**ALERT SERVICE BULLETIN
REVISION NOTICE**

SUBJECT: REVISION "B" TO ALERT SERVICE BULLETIN 230-04-31:

**TAIL ROTOR BLADE P/N 222-016-001-123, -123M, -131 AND -139M, INSPECTION
AND REWORK OF**

Revision "B" to this bulletin corrects the E-Mail address for Rotor Blades Inc and extends compliance date from May 31, 2008 to December 31, 2008.

Figure 1. Blade Inspection Area

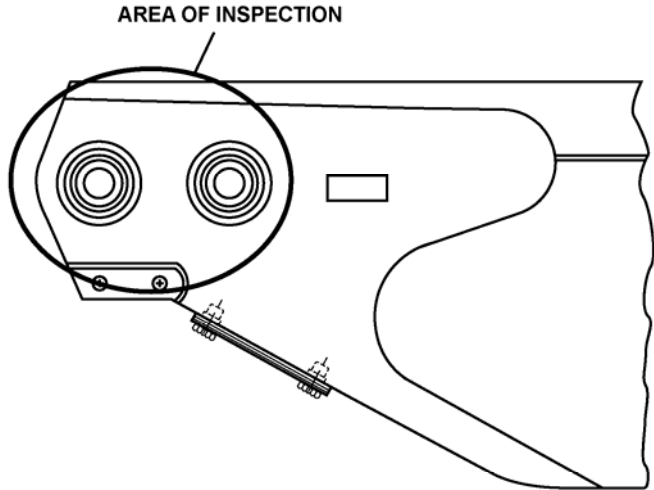
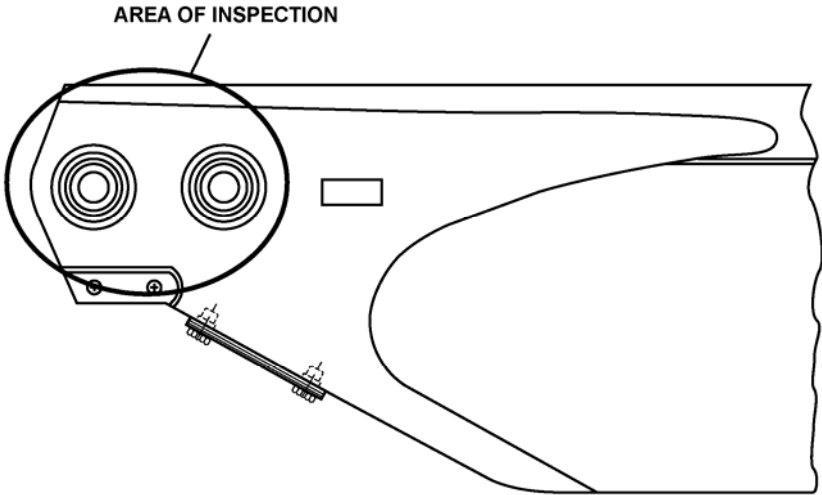
- a. Wipe down both surfaces of each blade around the blade feathering bearings using aliphatic naphtha (C-305) or detergent (C-318) or equivalents. Refer to Figure 1.
 - b. Closely examine the cleaned surface, on both sides of the blade, paying particular attention to the area around both bearings. If no crack is found in the paint, the inspection is complete until next inspection.
 - c. If a crack is found in the paint, maintenance personnel must proceed with step 2.
2. Remove the suspected blade from the helicopter. Refer to BHT-230-MM-7, Chapter 64.

- a. Wipe down both surfaces of each blade around the blade feathering bearings using aliphatic naphtha (C-305) or detergent (C-318) or equivalents. Refer to Figure 1.
 - b. Using a 10X power magnifying glass, closely examine the cleaned surface, on both sides of the blade, paying particular attention to the area around both bearings.
 - c. If no crack is found in the paint the inspection is complete until next inspection.
 - d. If a crack is found in the paint, proceed with step 2.
2. Remove the tail rotor blade from the helicopter. Refer to BHT-230-MM-7, Chapter 64.
